Access Compliance Report

Intersection ID: 21108	Main Street: PARK_SOUTH_DR	Cross Street: OLD_REID_RD	Location: S
ADA ID: 2B3353D7E632	Ramp Type: BlendTrans1	Initial Pass/Fail: Fail	Overall Compliance: No
		Severity Score: 10

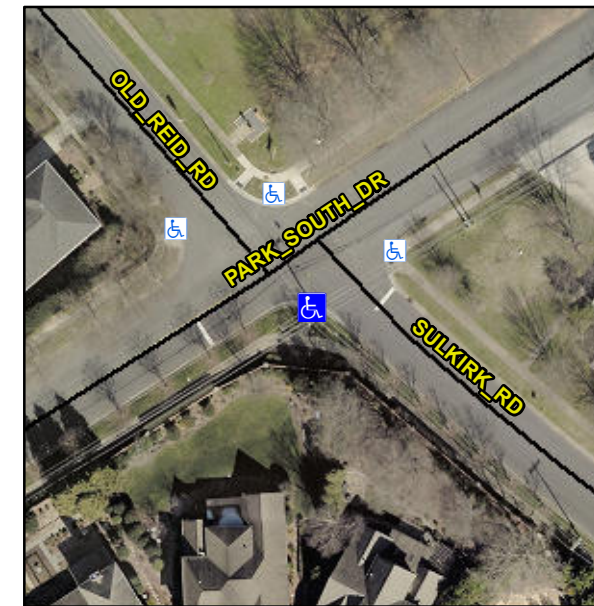
Not Found, R304.5.1, R304.5.3

Compliance	Description	Data	Compliance	Description	Data
N/A	Ramp Length (in)	47.0	Yes	BlendTrans Slope (%)	4.7
No	Ramp Width (in)	47.5	No	BlendTrans XSlope (%)	2.9
N/A	Flare Type LT	N/A	N/A	Flare Type RT	N/A
N/A	Flare Slope LT (%)	N/A	N/A	Flare Slope RT (%)	N/A
N/A	Flare Traversable LT?	N/A	N/A	Flare Traversable RT?	N/A
N/A	Landing Length (in)	N/A	N/A	DWS Provided?	N/A
N/A	Landing Width (in)	N/A	N/A	DWS Contrast?	N/A
N/A	Landing Slope (%)	N/A	N/A	DWS Length (in)	N/A
N/A	Landing X Slope (%)	N/A	N/A	DWS Full Width?	N/A
N/A	Landing Curb? (Y/N)	N/A	N/A	DWS Offset (in)	N/A
N/A	Shared Landing?	N/A			
N/A	Gutter Ponding?	N/A	N/A	Gutter Slope (%)	N/A
N/A	Gutter Lip Ht (in)	N/A	N/A	Gutter X Slope (%)	N/A
N/A	Painted X Walk1?	No	N/A	Painted X Walk2?	No
	X Walk 1 Direction	To NE		X Walk 2 Direction	To NW
	X Walk 1 Width (in)	N/A		X Walk 2 Width (in)	N/A
	X Walk 1 Slope (%)	4.4		X Walk 2 Slope (%)	1.6
	X Walk 1 X Slope (%)	0.5		X Walk 2 X Slope (%)	3.0

N/A	Ramp inside XWalk1?	N/A	N/A	Ramp inside XWalk2?	N/A
	Road Slope (%)	2.8		Clear Space?	N/A
	Road X Slope (%)	4.3	N/A	Clear Space to XWalk (in)	N/A
N/A	Any Obstructions?	N/A	N/A	Storm Grate/Utility Hazard?	N/A
	Obstruction Type			Storm Grate/Utility Type	
		N/A			N/A
			Yes	Surface Condition? (G/P)	Good
			No	Curb Slope (%)	10.8

Remove & Replace Curb Ramp With Two New Directional Ramps or Equivalent.
